## DECISION OF THE PLANNING ADMINISTRATOR

**SUBDIVISION TENTATIVE PLAN / CLASS 2 ADJUSTMENT CASE NO.: SUB-ADJ25-02**

**NOTICE OF DECISION DATE:** May 1, 2025

**LOCATION:** 4208 and 4258 Market St NE, Salem OR 97301

## CORNER OF MARKET AND TIERRA - SUBDIVISION TENTATIVE PLAN

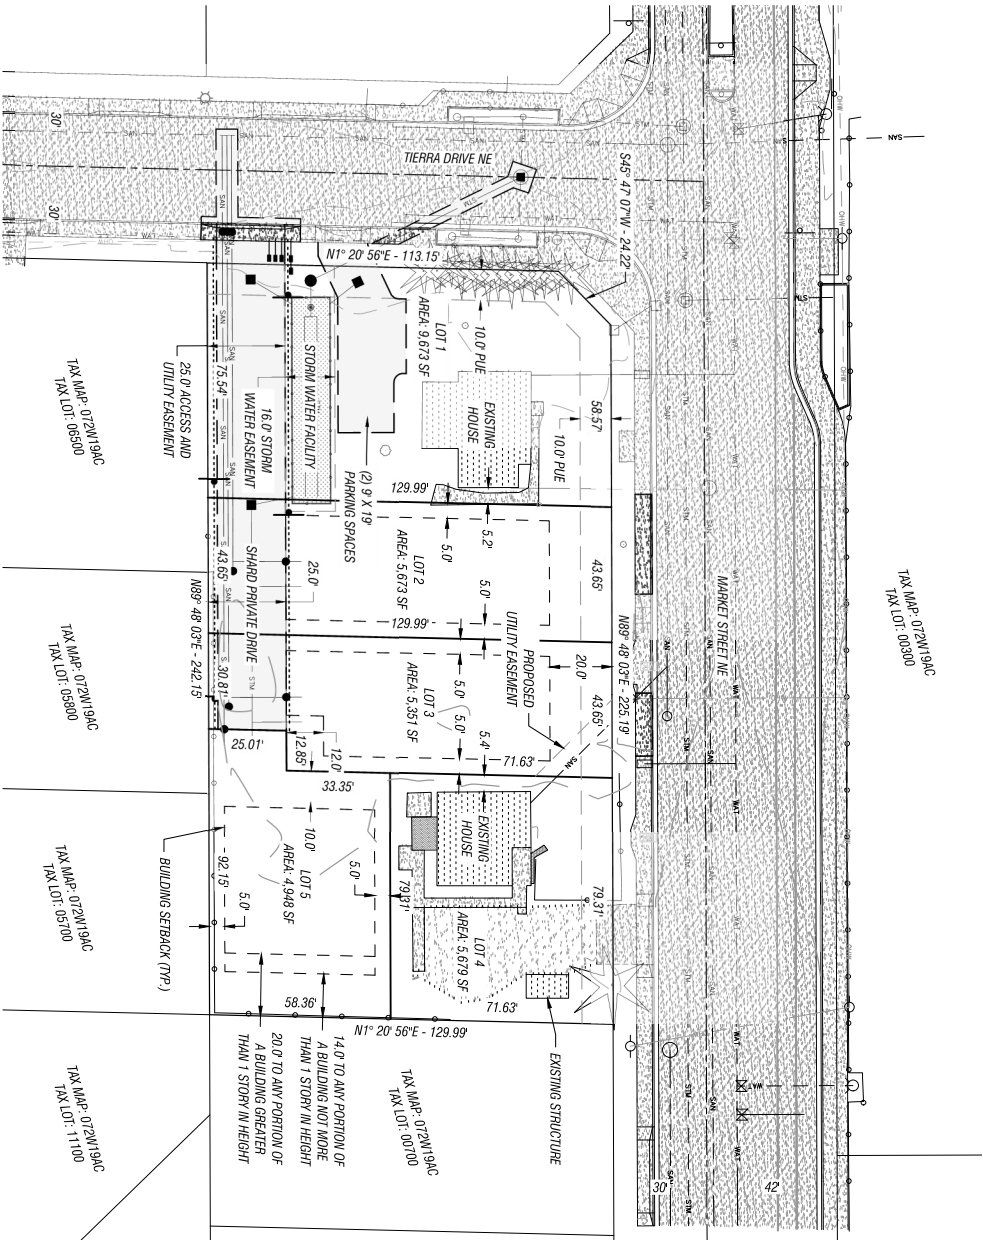
**Finding:** Lot 5 as proposed on the tentative plan includes a 13-foot extension toward the west where it abuts the terminus of the flag lot accessway. This area of the lot conflicts with the access of Lot 3 onto the flag lot accessway. To ensure this area can be used for access for both Lots 3 and 5, prior to final plat, the applicant shall revise the plan to include this area within the flag lot accessway, bringing the front lot line of Lot 5 in line with the west property line between it and Lot 3.

**Condition 2:** Prior to final plat, revise the tentative subdivision plan so that the front lot line of Lot 5 is a direct continuation of the property line separating Lot 5 from Lot 3.
